# REZONING STAFF REPORT REZ-25-0000097

**DATE OF REPORT:** 12/04/2025

PD (Planned Development) Residential Multi-Family

The Development Review and Compliance staff has reviewed the petition and finds the request **INCONSISTENT** with the applicable City of Tampa Land Development Regulations. See findings from Natural Resources, Development Coordination and Transportation in report below. Should it be the pleasure of City Council to approve the application, further modifications to the site plan must be completed by the applicant in between 1<sup>st</sup> and 2<sup>nd</sup> Reading of Ordinance as stated on the revision sheet. These revisions will not resolve the issues of Transportation's inconsistent finding.

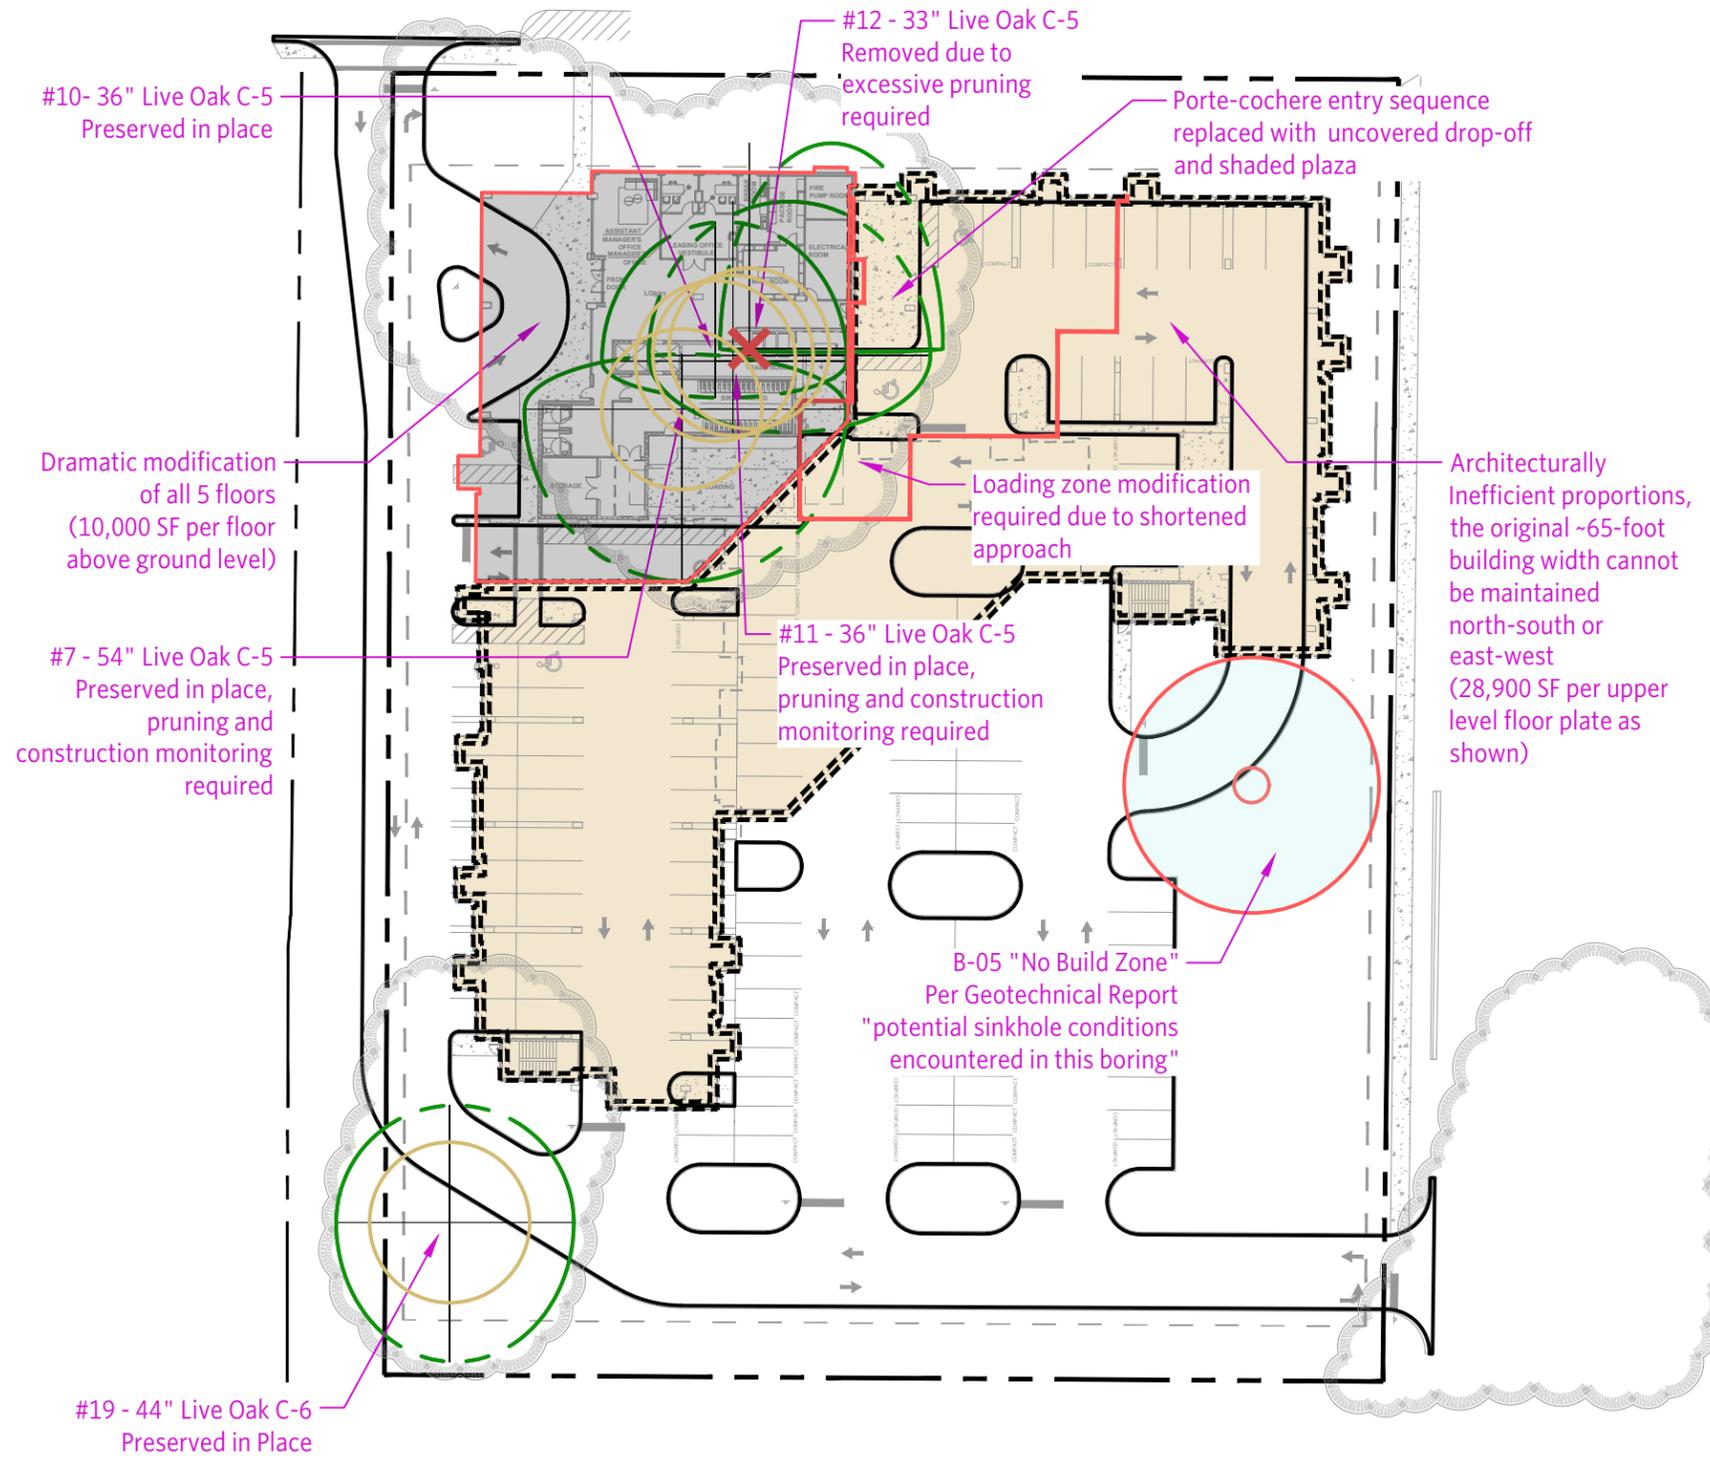
- Update the total VUA calculation to 34,642 in the site data table and the landscaping table.
  - Show the site tree requirements and greenspace as follows either in the Site Data Table or in the Landscape Table.

- MF trees =  $(97,352 - (34642 + 31133))/1500$  sf = 22 trees
  - 1 tree required per 40 lf of any VUA that fronts the right of way =  $310/40 = 8$  trees required

- 1 tree required per 1500 sf of VUA.  $34642/1500 = 24$  trees required
  - Total required trees = 54 trees required
  - VUA greenspace – 20% \* 34642 = 6928 sf

- MF greenspace =  $350 * 118 = 41,300$
  - Total overall greenspace =  $41,300 + 6928 = 48228$  sf required
  - $29857 - 6928 = 22929/118 = 194$  sf per unit greenspace provided per unit. A waiver is needed to reduce the required multifamily greenspace. Amend waiver #5 to 194 sf per unit. Write the waiver as shown below in the waiver section

- Add additional trees (Type 2 podocarpus macrophyllus) along the east side between the Type 1 shade trees and the building, and staggered between the Type 1s.

- Add additional screening of the car park on the ground floor to the landscape plan.
- Remove the 3<sup>rd</sup> column on the LS-00 table as the trees provided are required trees and not mitigation trees. Only four trees can count towards mitigation trees.

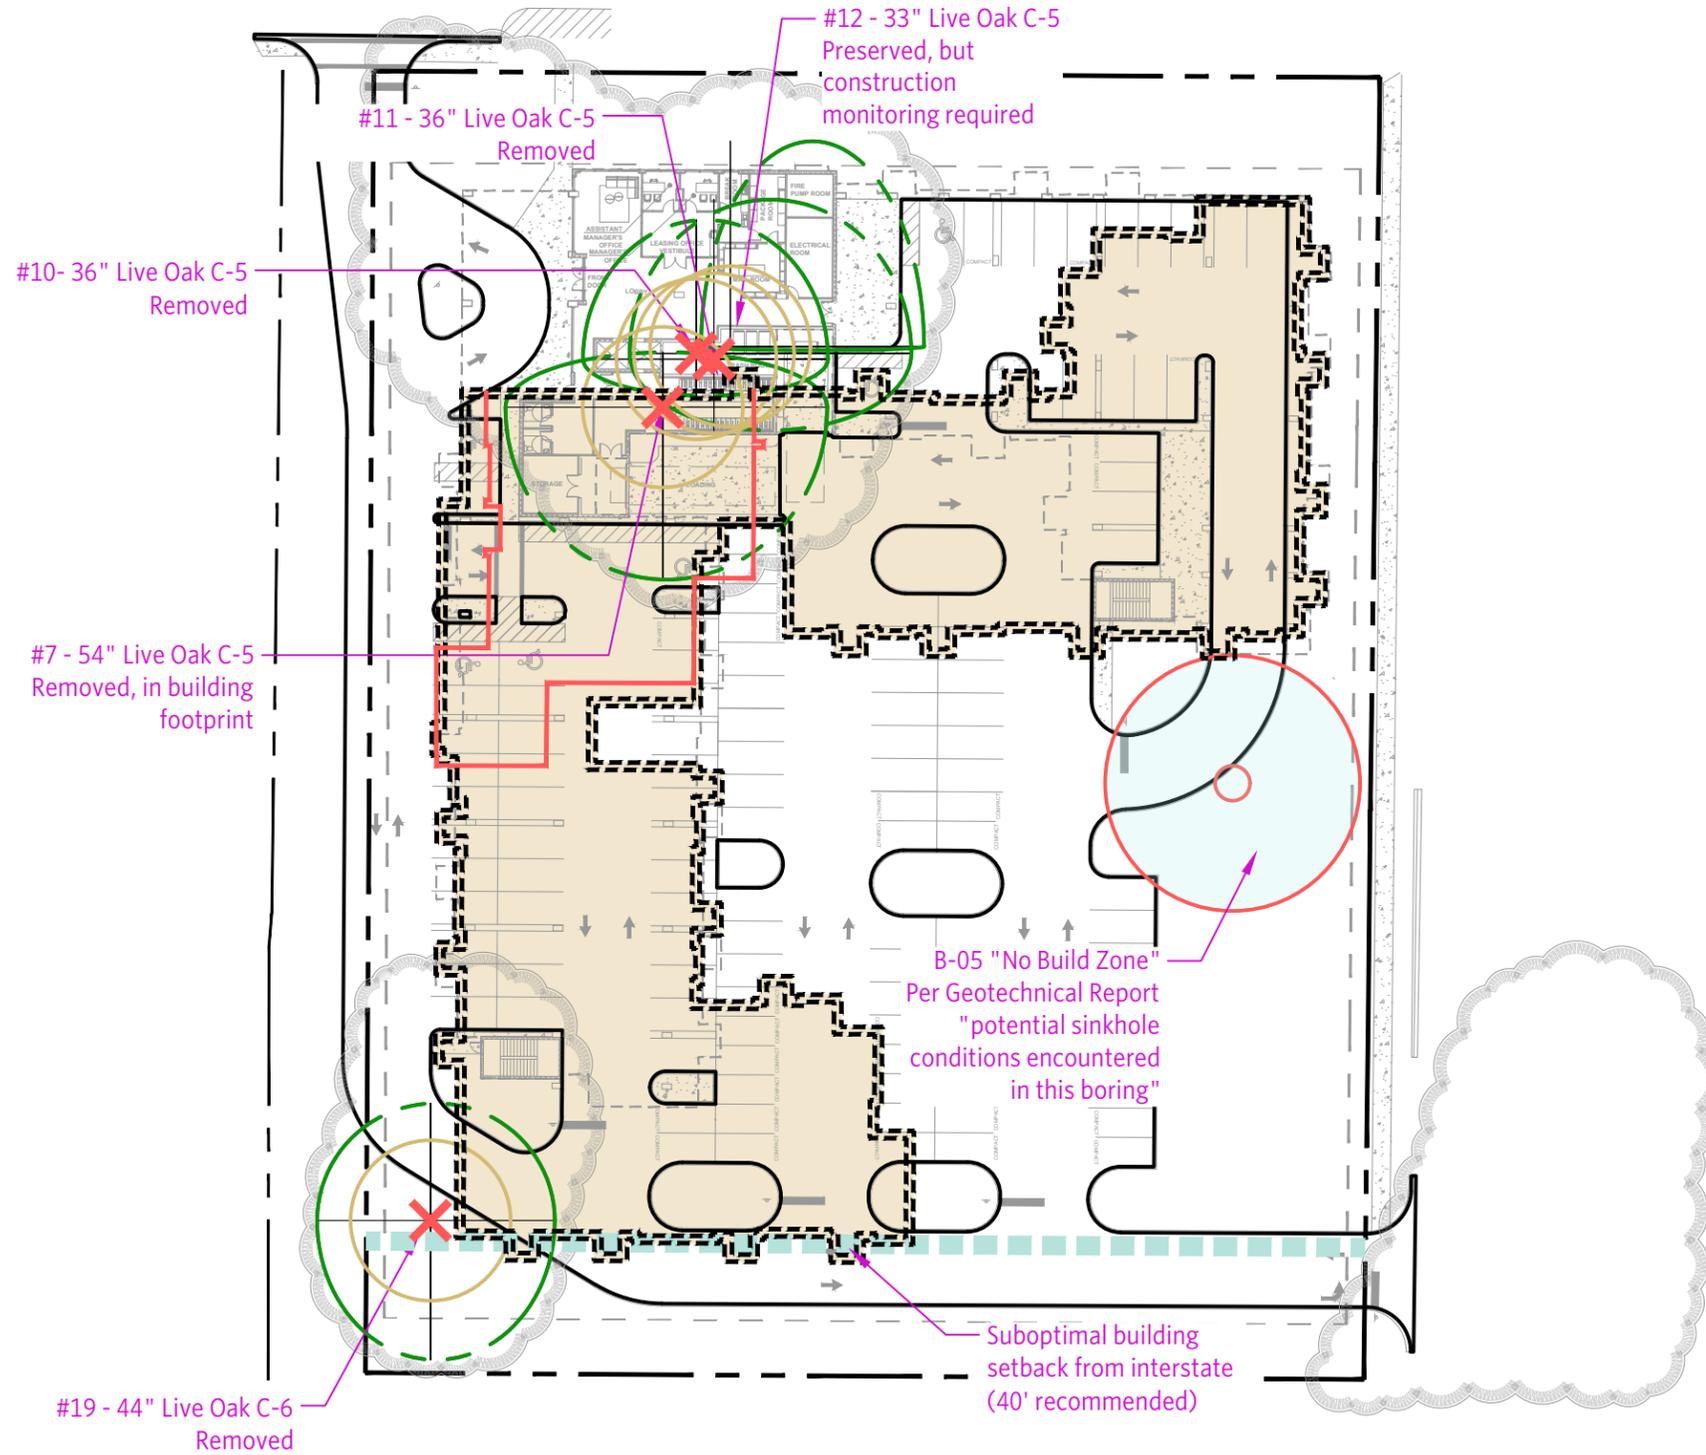
1. The inefficiency of the reconfigured northeast building massing is difficult to illustrate. The massing is effectively two building widths touching each other, similar to dumbbell tenements in New York City in the late 19th century. This type of architectural form was outlawed in 1901 due fire and sanitation issues. As depicted, interior units would have limited access to air and light.
2. This analysis assumes that encroachment into the B-5 "No Build Zone" is patently unreasonable.

## Ashley East Reasonable Reconfiguration Option 2

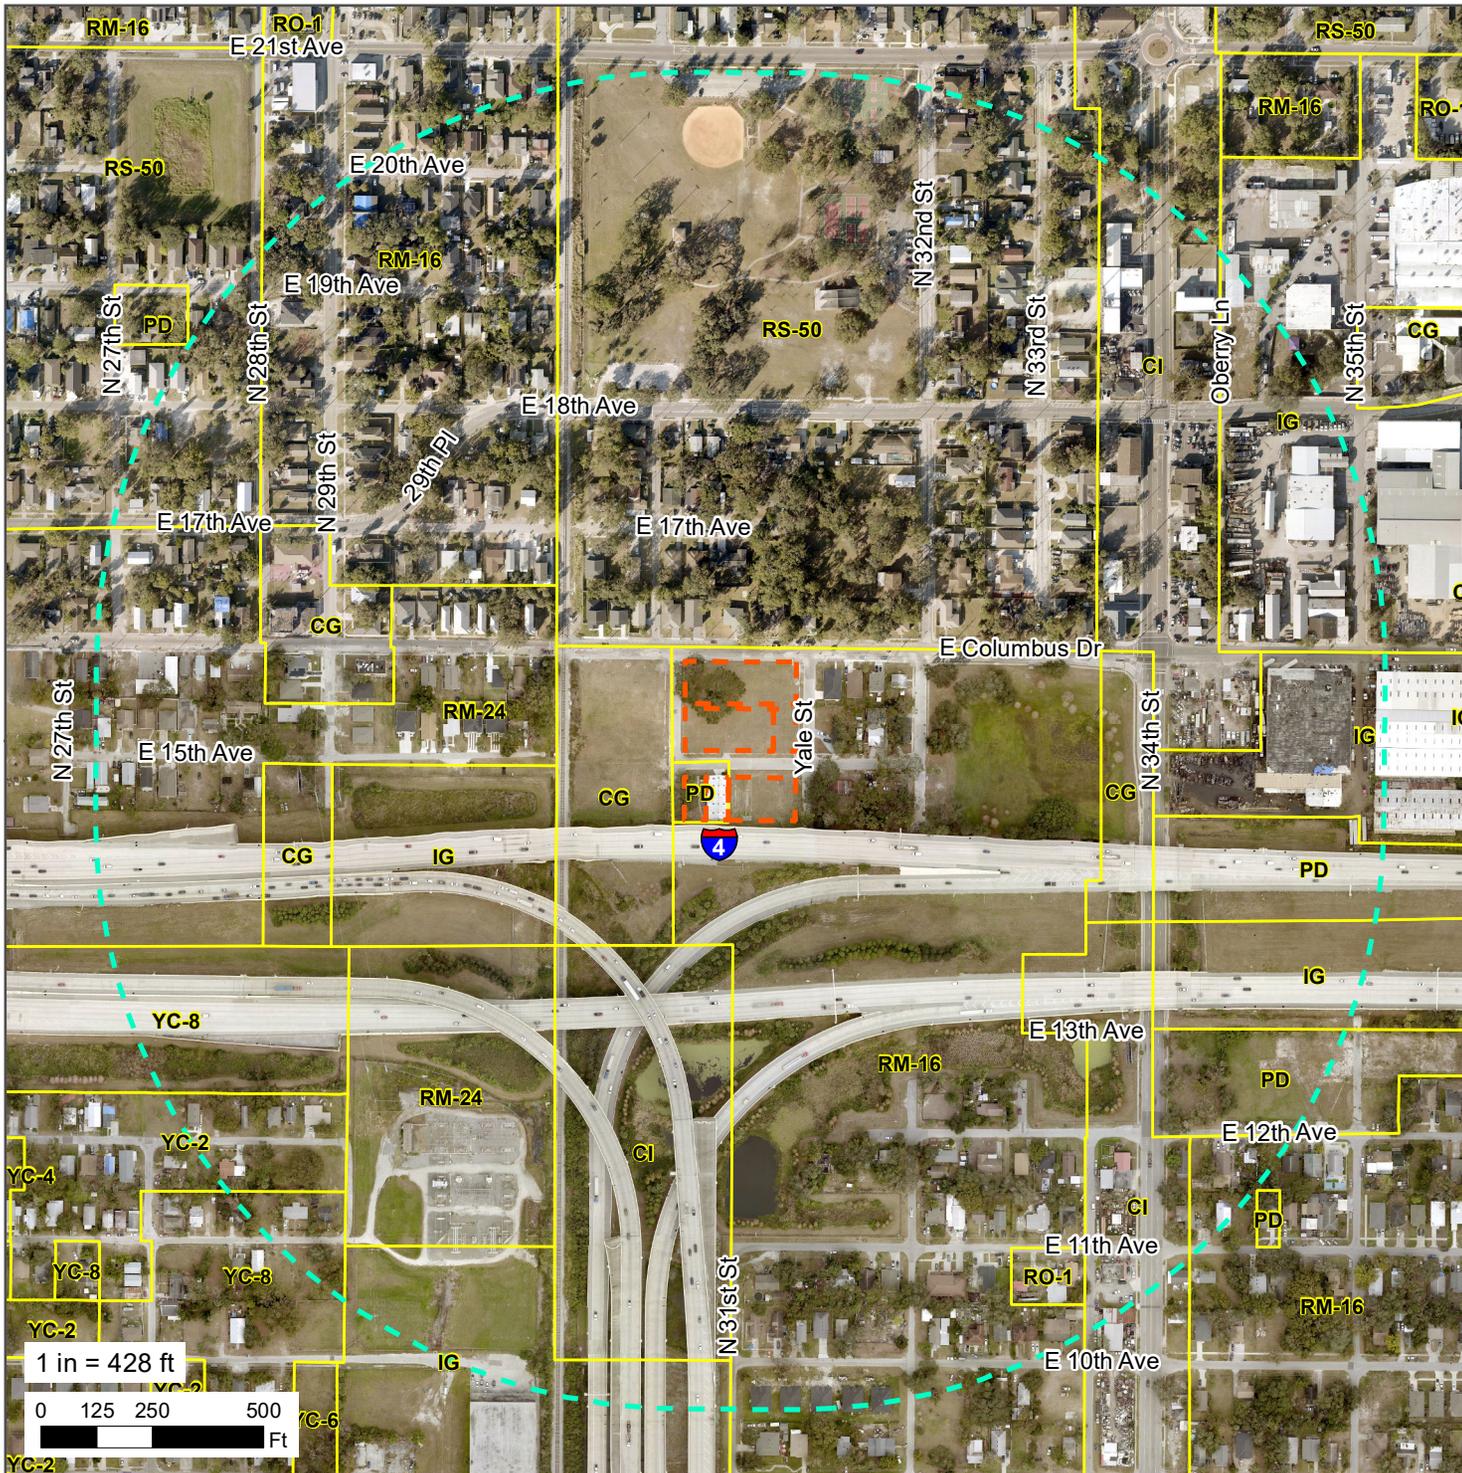
1. The jagged shape of this arrangement may not be consistent with the East Tampa Overlay Front Orientation provision. This orientation is not compatible with the pattern of immediately adjacent blocks.
2. This analysis assumes that encroachment into the B-5 "No Build Zone" is patently unreasonable.
